ARCHITECT'S SUPPLEMENTAL INSTRUCTIONS

PROJECT:	The Reserves at Magnolia New Apartment Complex Denton, TX	Report No.	One (1)
OWNER:	Overland Property Group Dan Maximuk 234 N. Santa Fe Ave, Suite A Salina, KS 67401	Date	Oct. 22, 2024
CONTRACTOR:	Snyder Construction Group 4820 N. Town Centre Dr. Ozark, MO 65721	Architect's Proj No.	21-3205
		Contract For:	General Construction Mechanical, Electrical

Please Note: Drawings and Specification Edits associated with this ASI are dated as **7-17-2024**. This date above is the date this ASI was issued.

A8.3

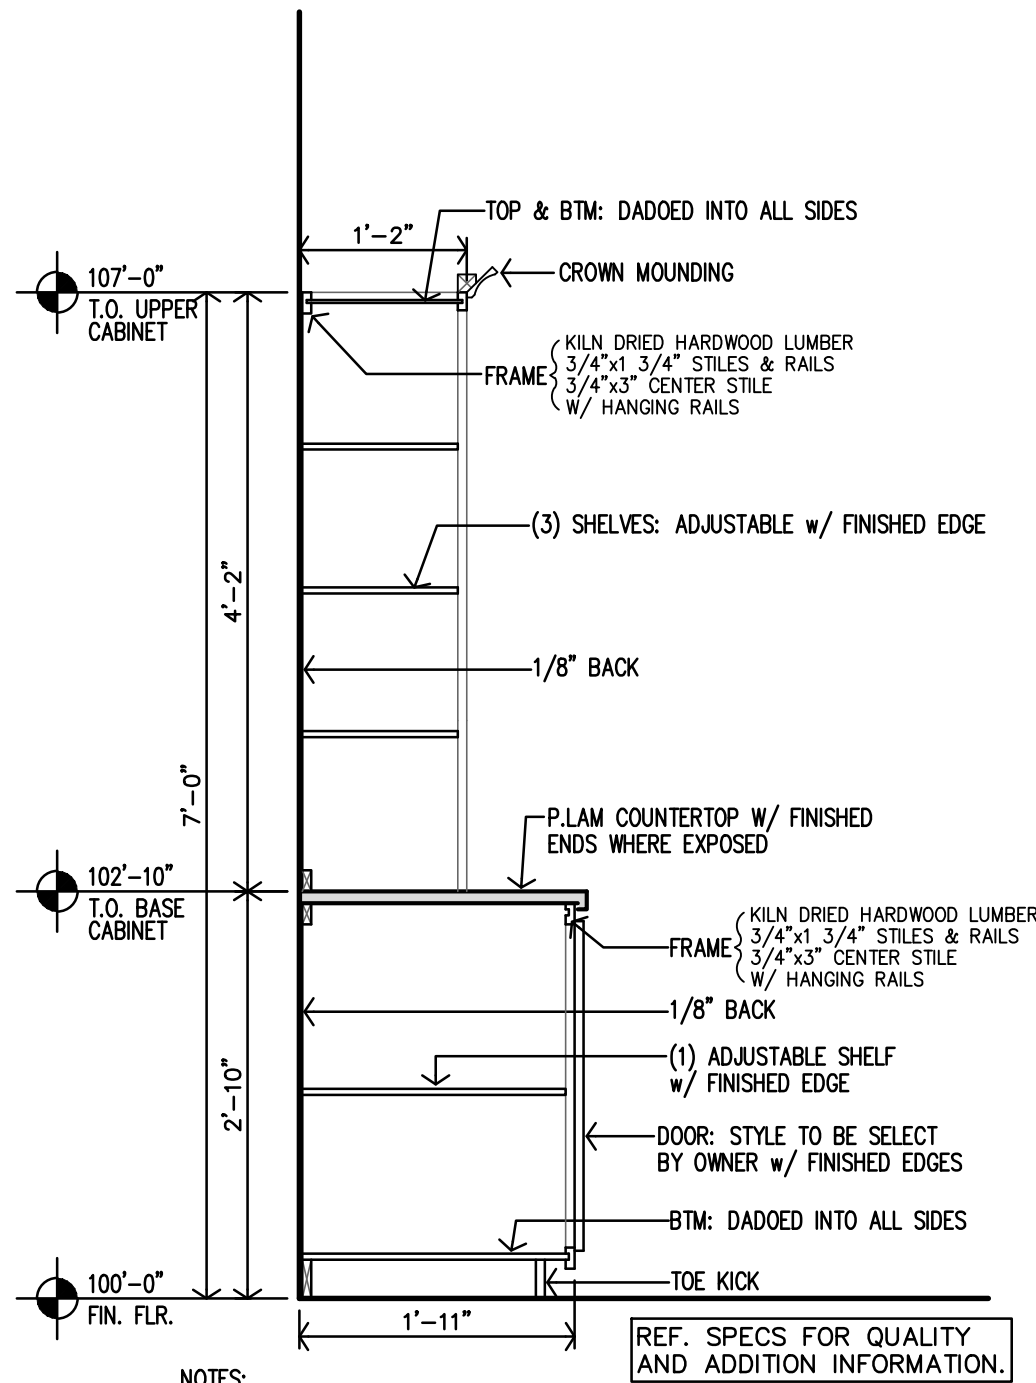
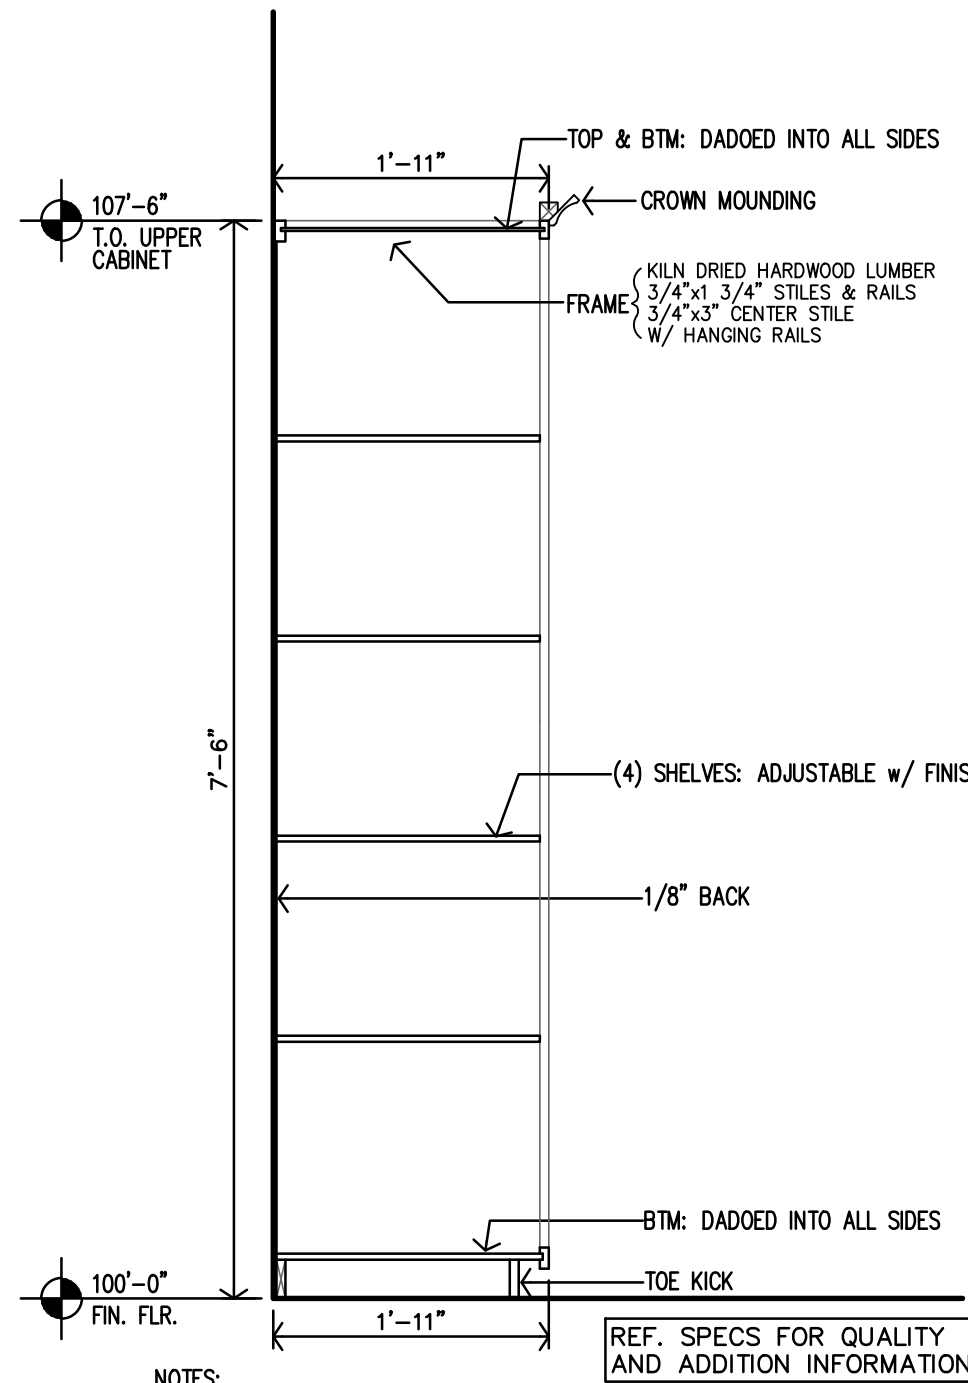
- 8) Utilize 5/8" OSB Roof deck sheathing in lieu of the specified 3/4" Zip System Roof Sheathing. (VE Item #11)
- 9) Casework in Food Pantry #107 has been reduced and reconfigured. (VE Item #12). Reference revised plan on Sheet A2.1 and revised details on Sheet A8.3.

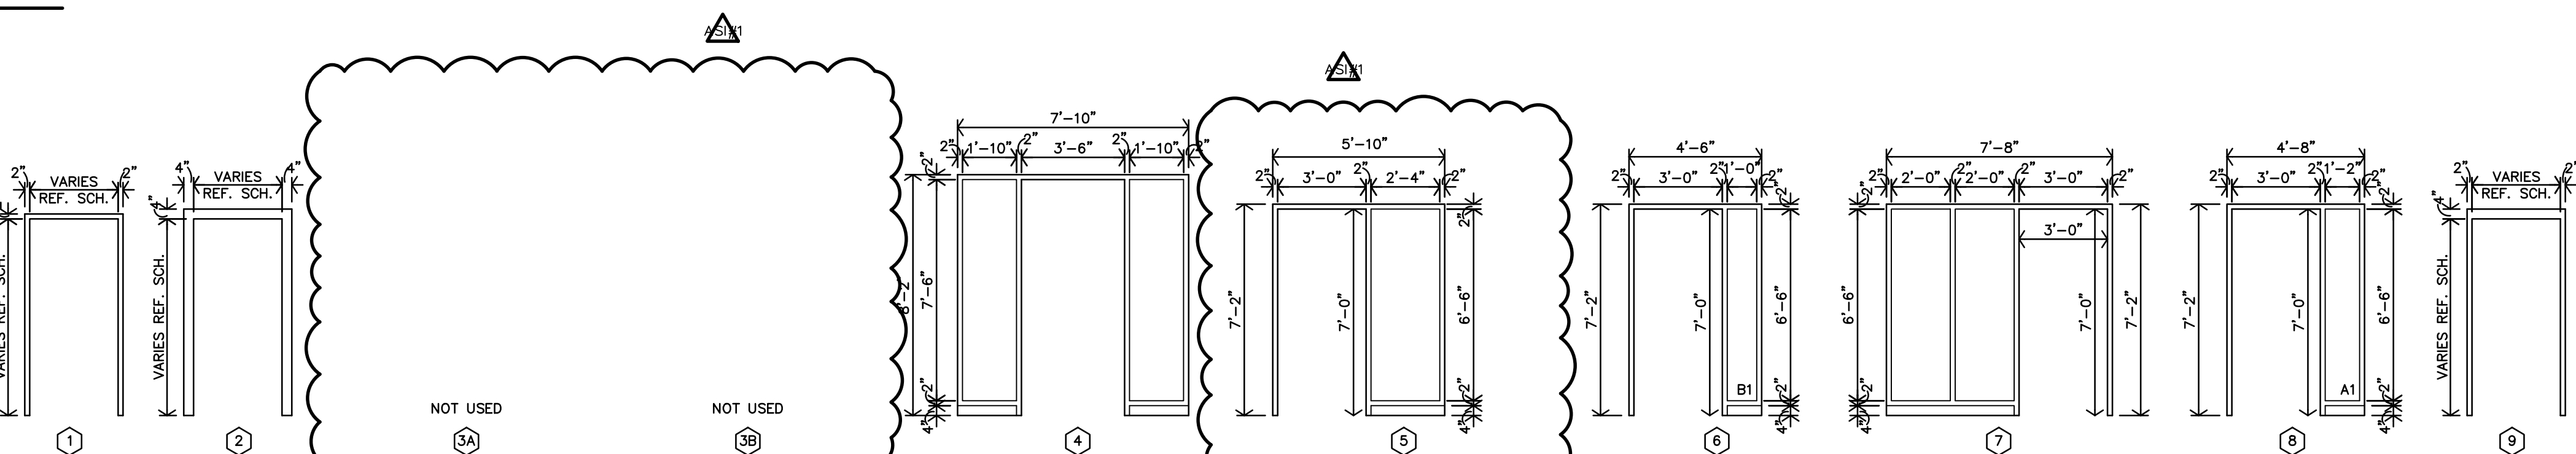
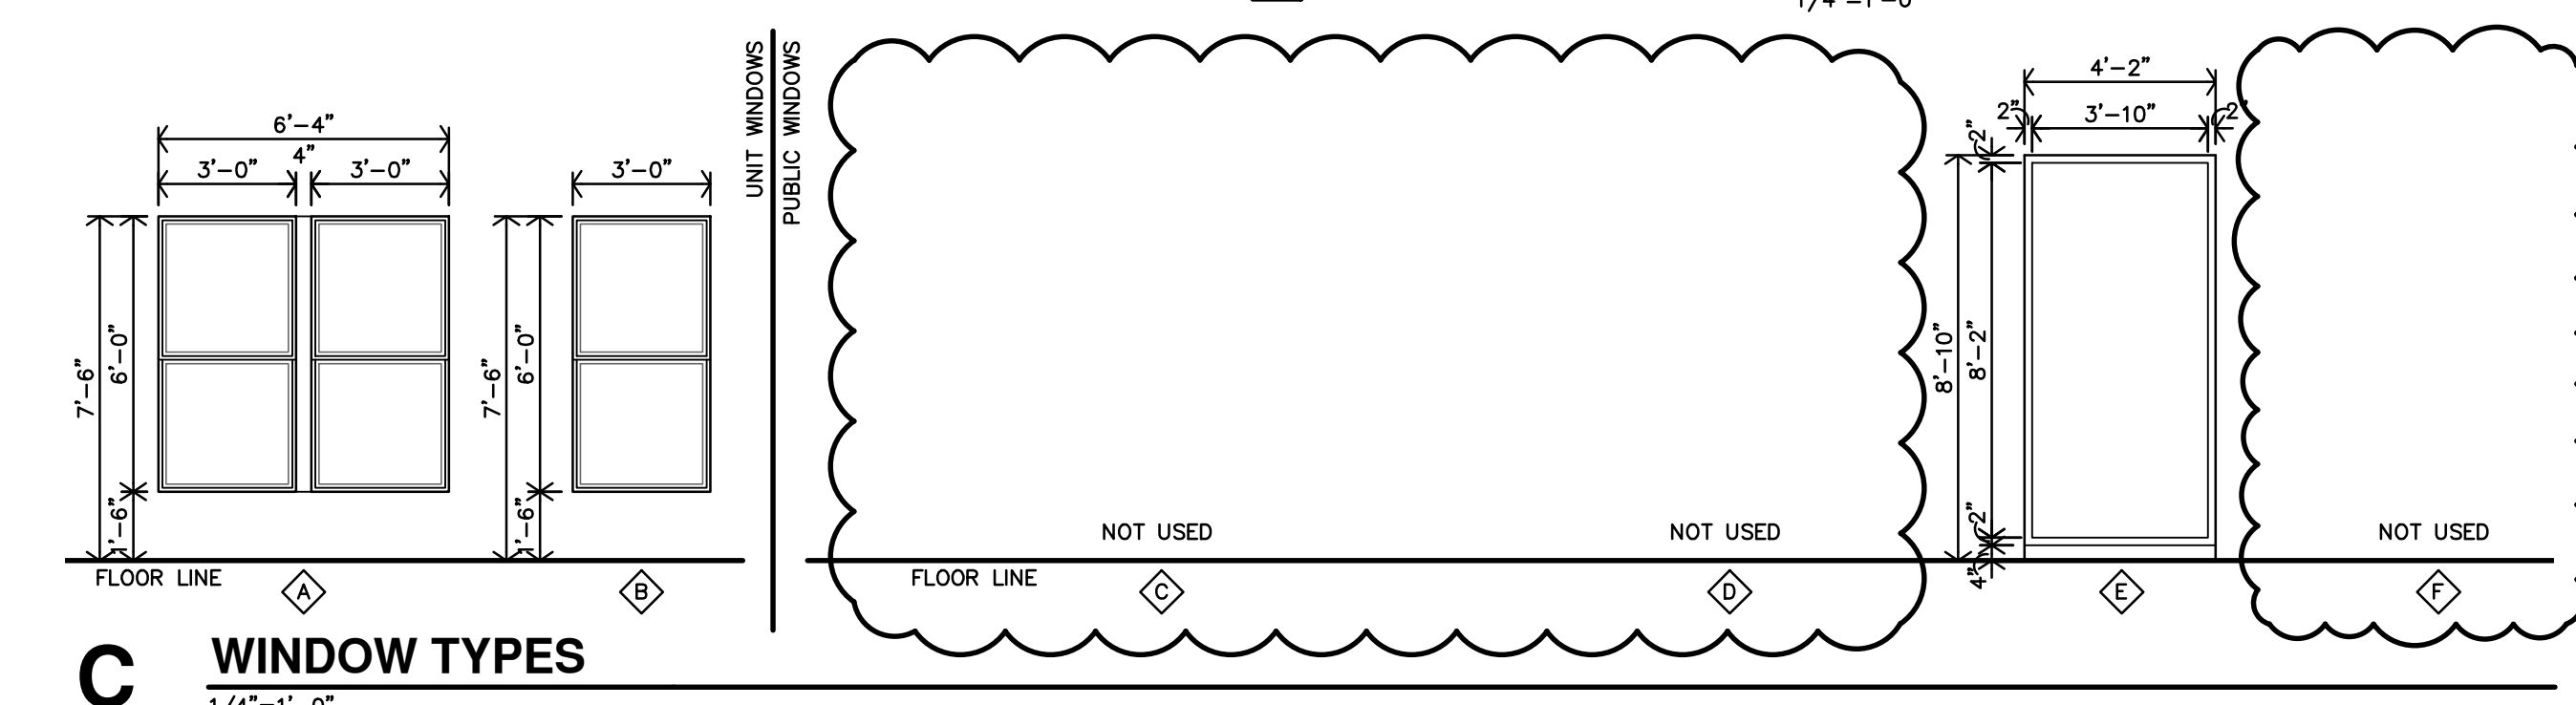
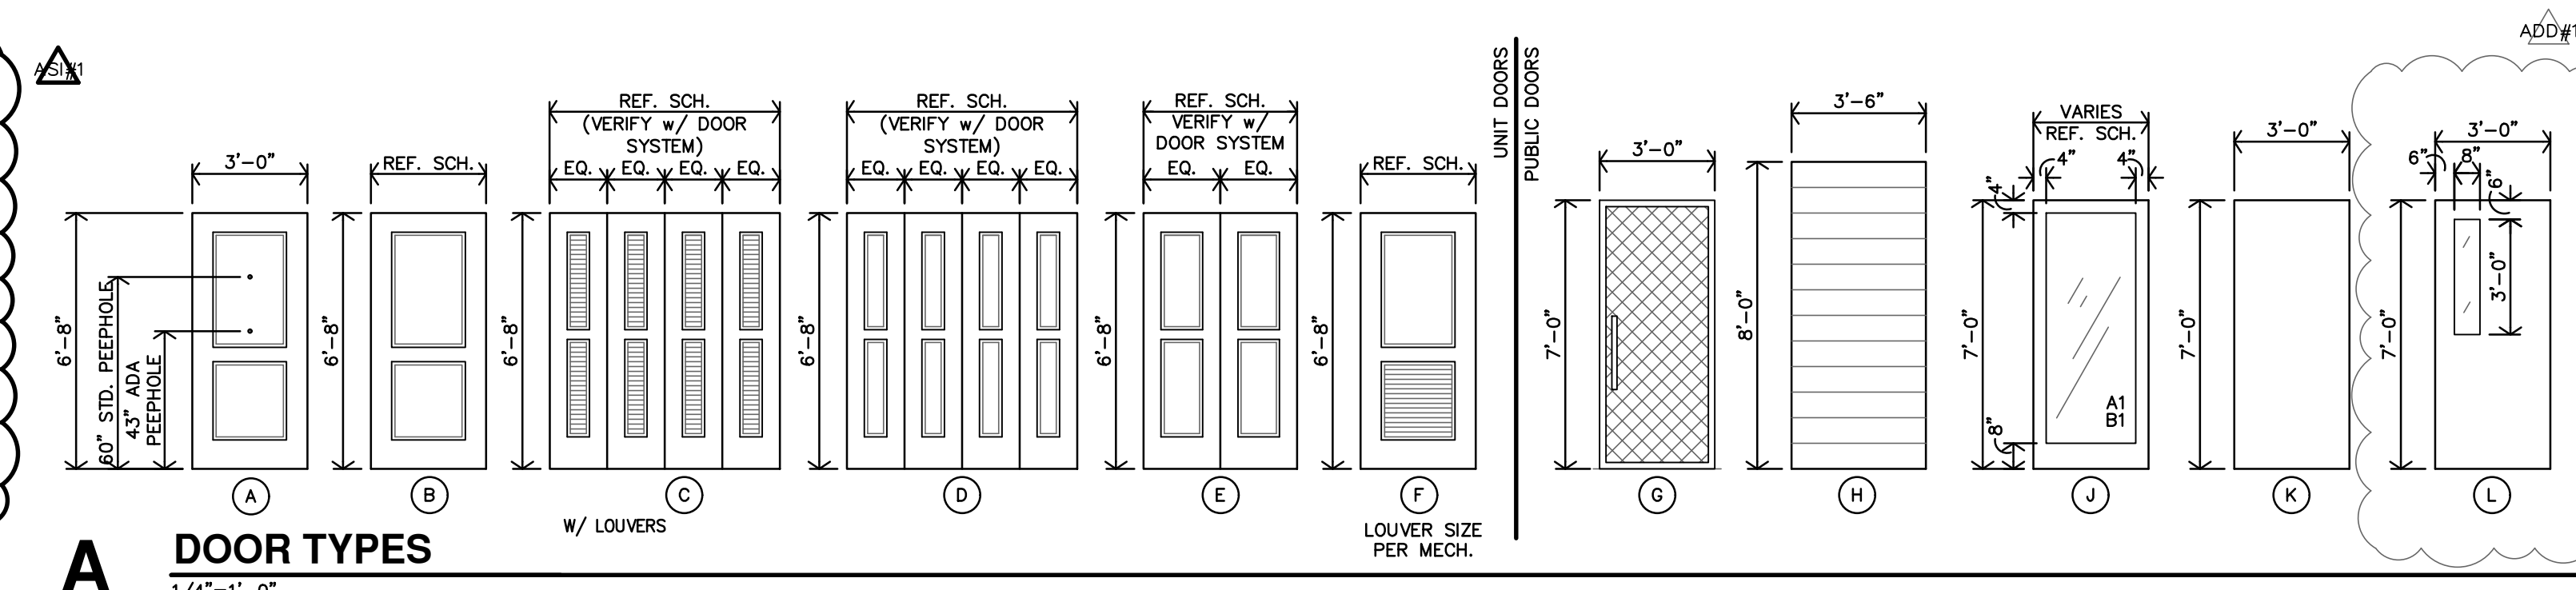
- 18) Utilize 20-minute rated PVC Composite Door Jambs in lieu of 20-minute Hollow metal Door Jambs. Reference revised Sheet A10.2 (VE Item #23)
- 19) Reduce the indicated door hardware allowance from \$120,000 to \$60,000. (VE Item #24)

- 38) Reduction in Storefront (VE Item #44) Reference revised Sheets A2.1, A3.1 and A10.2
 - a. Omit Storefront Windows C & D, replace all with Window A.

- b. Storefront Door 101 (frame type 5) has been reduced in size.
 - c. Storefront window F has been eliminated.
 - d. Door 102 has been changed to a Solid Core Wood Door with Hollow Metal Frame, Frame type 1.

- e. Door 104 has been changed to a Solid Core Wood Door (type L) with PVC Composite Frame (type 1). Door and frame to be rated 20-minute.
 - f. Doors 107, 109, 111 & 112 have been changed to a Solid Core Wood Door with Hollow Metal Frame.
